Memorandum

March 23, 2023

Re: Final Revised Additional Depth of Contamination Characterization Addendum within the Gasco Sediments Site Project Area

Figure 2
Proposed Subsurface Depth of Contamination Refinement Cores and Riverbank Angled Borings
 Final Revised Additional Depth of Contamination Characterization Addendum Within the Gasco Sediments Project Area
 Gasco Sediments Cleanup Action

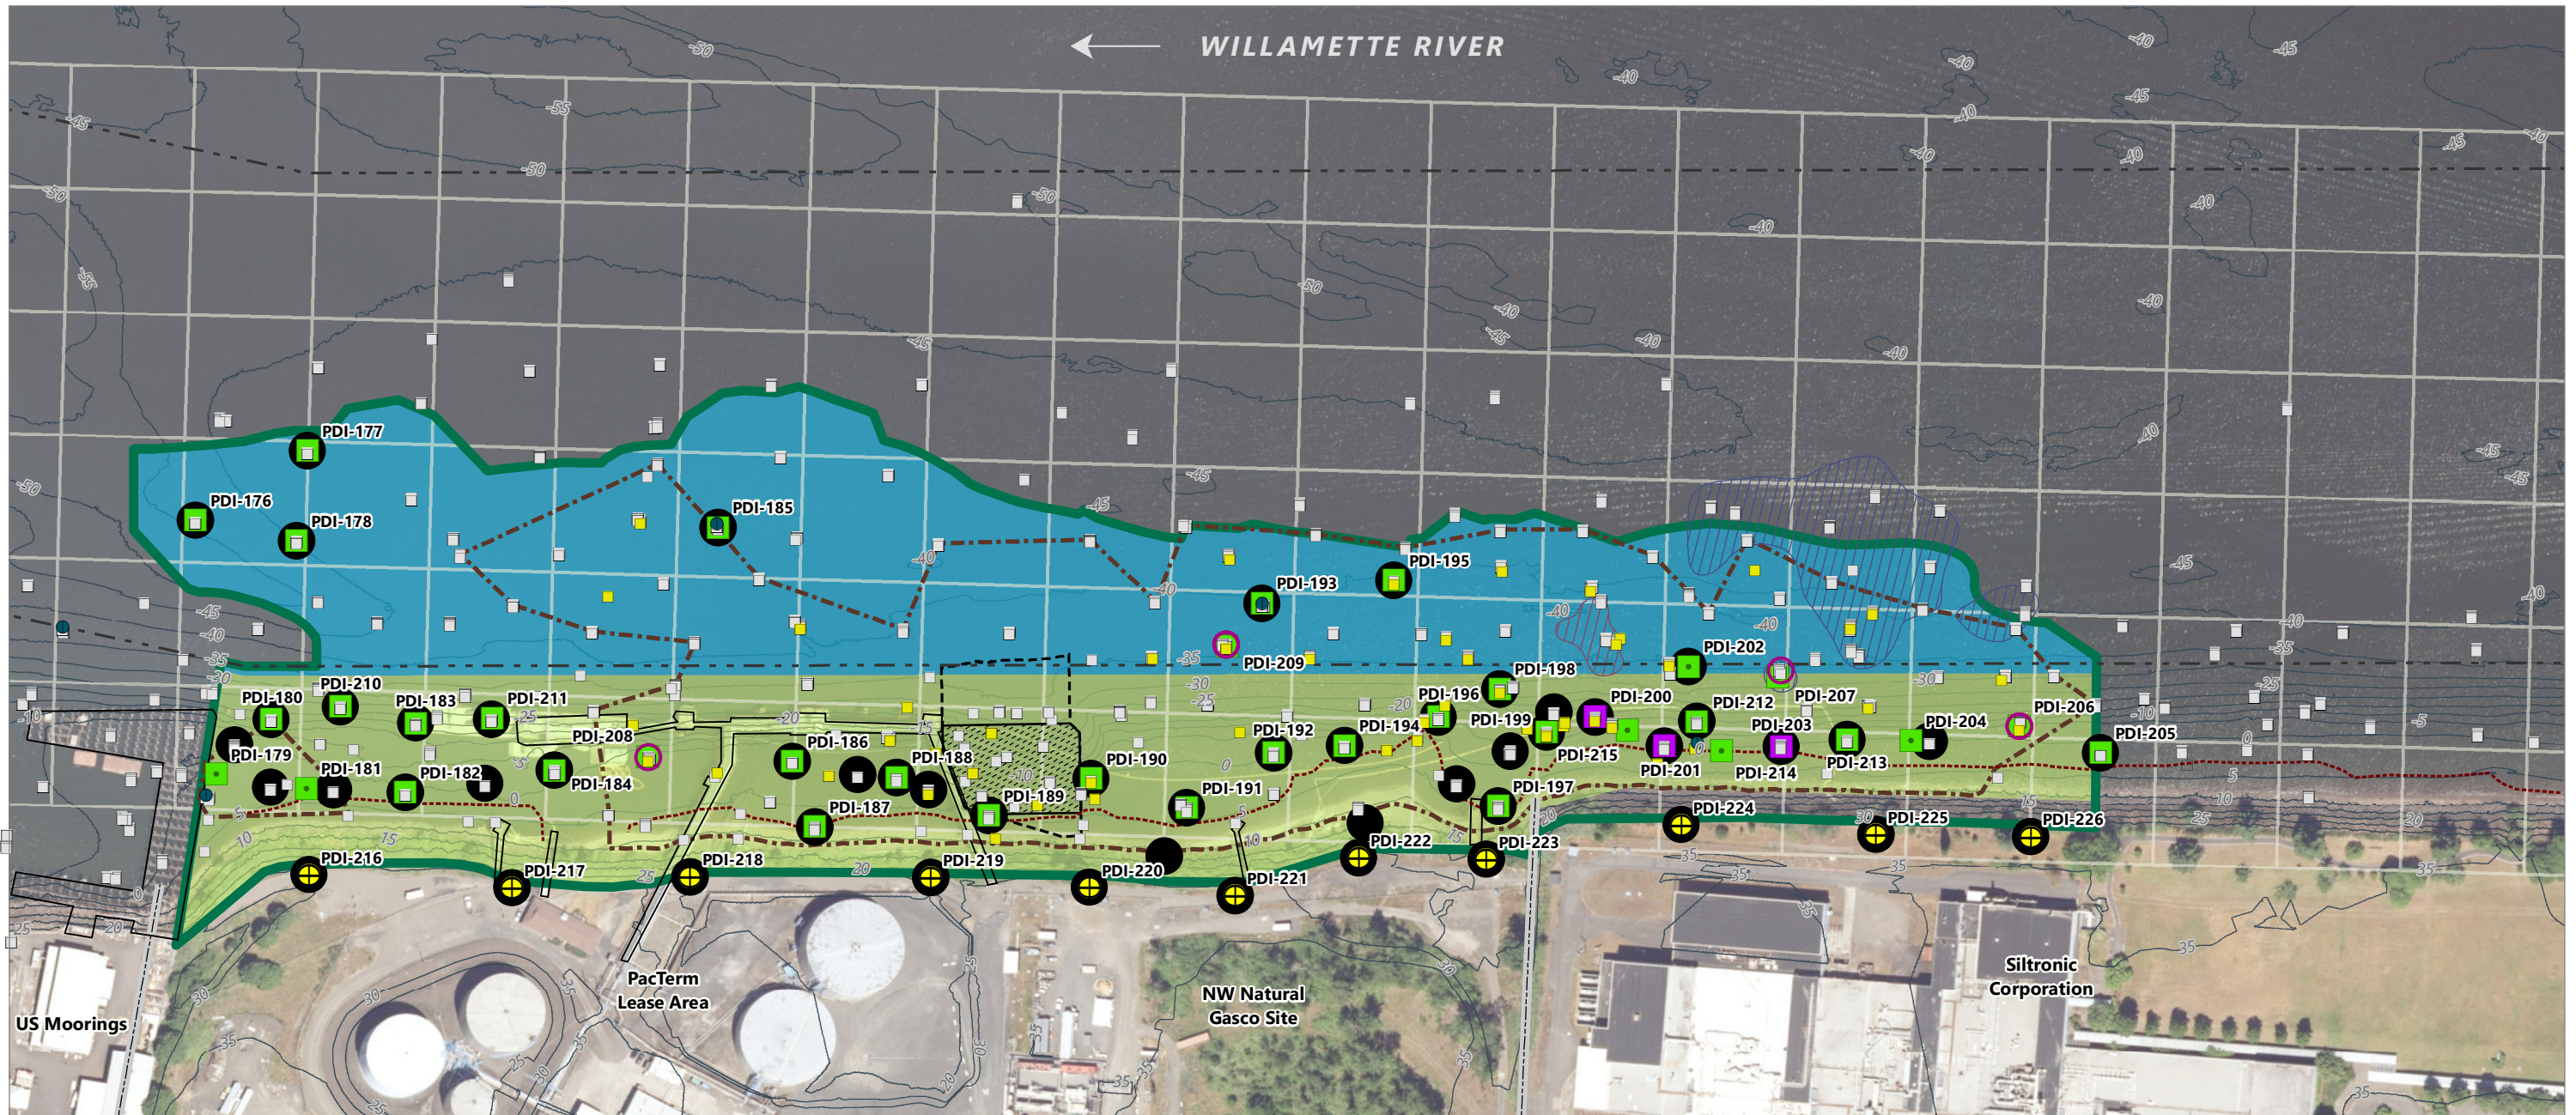
Contingency Cores: The intended purpose of the contingency coring locations PDI-212 and PDI-213 included in Figure 2, Figure A-2, and Table A-1 should be discussed in the main DOC Addendum text, along with the criteria to be used to trigger sampling at these locations.
